T10/03-380r1

To
INCITS T10 Committee

From
Michael Banther, HP

Subject
ADT Baud Rate Fallback

Figure 1

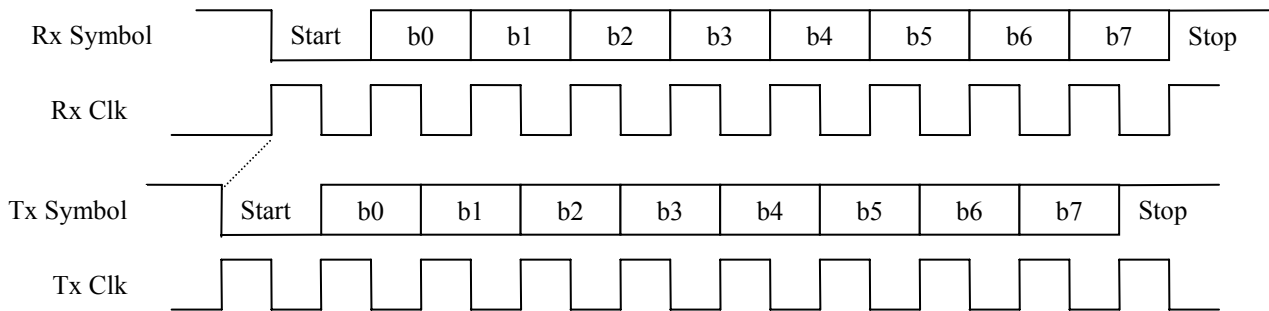
Figure 1 shows the clock relationship between a transmitting and receiving port under normal operation.

Figure 2

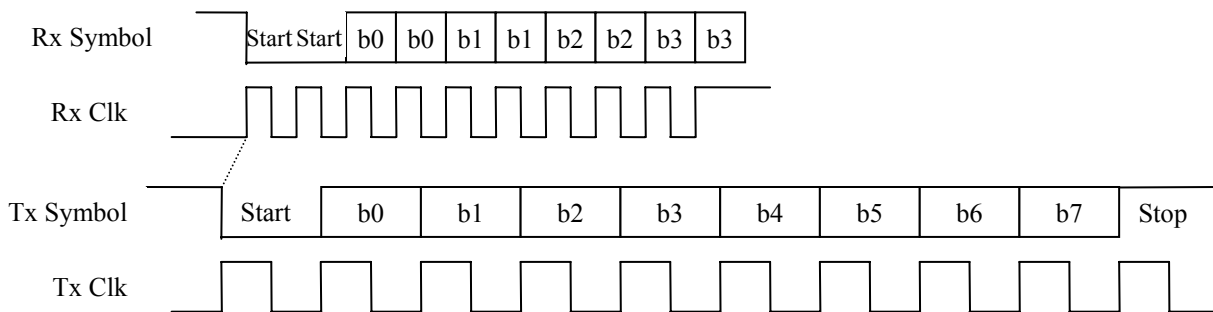
Figure 2 shows the clock relationship between a transmitting and receiving port when the receiving baud rate exceeds the transmitting baud rate by a factor of two.

If the transmitter sends an SOF (5Bh) with a one bit gap before the next byte, the receiver running at twice the baud rate may receive 19h, 7Fh:

1. The transmitter encodes 5Bh as 0 0101 1011 11b,
2. By double sampling, the receiver detects 00 0011 0011 1100 1111 1111b,
3. The receiver decodes this string as:
 - 1) 0 0001 1001 1b,
 - 2) 11b (additional stop/idle bits),
 - 3) 0 0111 1111 1b.

Note that if the transmitter did not leave a one bit gap, the receiver will still receive 19h, but it will detect a framing error in place of the 7Fh because the Stop bit for that symbol will have the value zero.
